Re: *American Transmission Systems, Incorporated's Letter of Notification
Application for a Construction Certificate
Leroy Center-Mayfield Q1 and Q2 Transmission Lines Partial
Reconductor Project
OPSB Case No. 22-0747-EL-BLN*

In the Matter of the Letter of Notification)
Application by American Transmission) Case No. 22-0747-EL-BLN
Systems, Incorporated for a Construction)
Certificate for the Leroy Center-Mayfield)
Q1 and Q2 138 kV Transmission Lines
Partial Reconductor Project

ATSI'S RESPONSE TO FIRST DATA REQUEST SET FROM OPSB STAFF

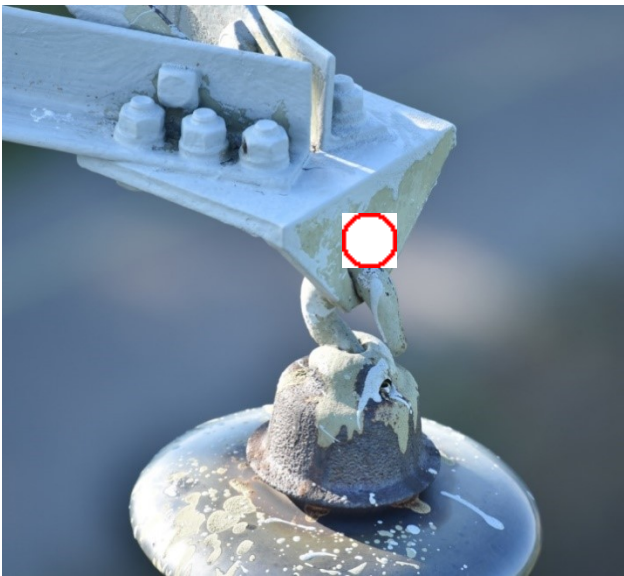
10) Please provide additional description, clarification, and/or illustration of the “measurable cold end attachment plate wear” and “mounting holes”, mentioned on pages 3 and 4 of the application.

RESPONSE: The cold end attachment plate mounting hole is the point of the structure that is used for attachment of the insulator mounting hardware (hook, clevis, or other). The wear observed, the elongation of the mounting hole, is of general material wastage or deformation at the point of connection from its original state. Pictures below illustrate the original circular shape of the mounting hole (red circle). Note the location of the insulator mounting hardware below the circle, which indicates deformation and elongation of the hole and plate.
